THE MARYLAND-NATIONAL CAPITAL PARK AND PLANNING COMMISSION

Item # 3
MCPB
December 4, 2003

DATE: November 26, 2003
TO: Montgomery County Planning Board
VIA: Joe R. Davis, Chief *JRD*
Michael Ma, Supervisor *Ma*
Development Review Division
FROM: Wynn E. Witthans, RLA, AICP *W*
Planning Department Staff
(301) 495-4584
REVIEW TYPE: Site Plan Review
APPLYING FOR: Approval of 6 townhouses on 24,733.8 square feet
PROJECT NAME: Towns at Rosedale Park
CASE #: 8-04007
REVIEW BASIS: Div. 59-D-3, Montgomery County Zoning Ordinance for Site Plan
ZONE: RT-12.5
LOCATION: Chestnut Street 180 feet east of Wisconsin Avenue or MD Route 355.
MASTER PLAN: Bethesda/Chevy Chase and Vicinity
APPLICANT: Magruder/Reed Communities, LLC
FILING DATE: September 23, 2003
HEARING DATE: December 4, 2003

TOWNS AT ROSEDALE PARK (8-04007)

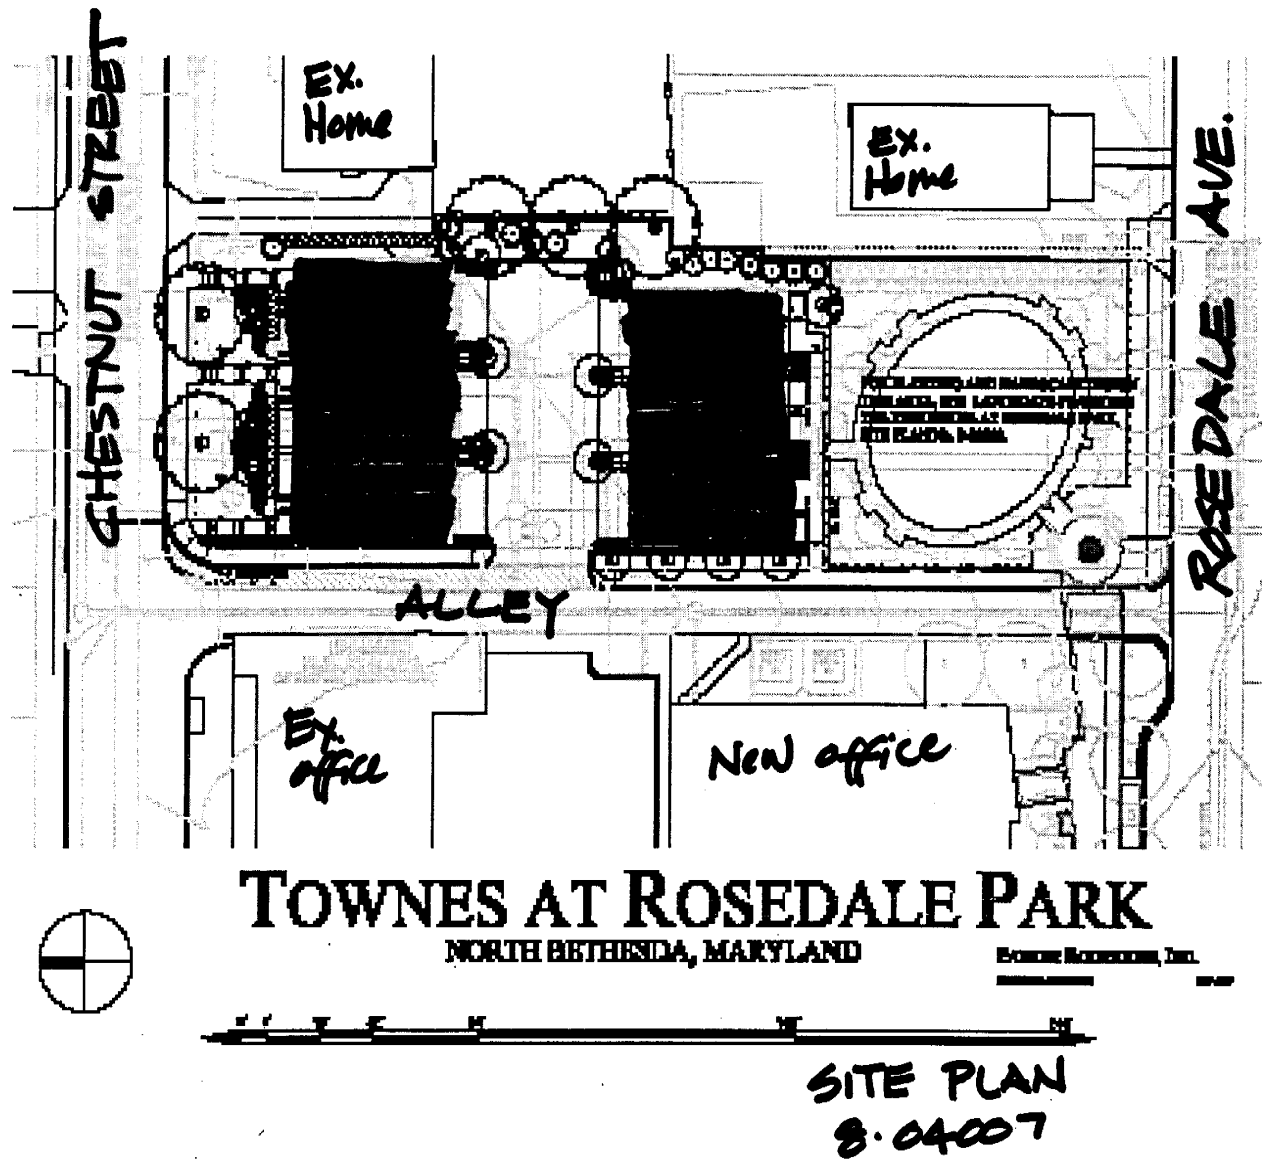
The project proposes 6 townhouses in two groups of three, facing either Chestnut Street or the park at Rosedale Avenue. The units are served from a one- and two- way alley to the west. The parking alley is screened from adjacent residential back yards via a 6-foot wooden fence to the east.

Pedestrian access is provided to the front of each unit and along the north-south alley on the east side. A public sidewalk is provided along the curb of the Chestnut Street frontage.

Landscaping includes street trees, front entry planting and side yard screen planting. Low-level lighting is provided within the front and rear yards of the townhouses.
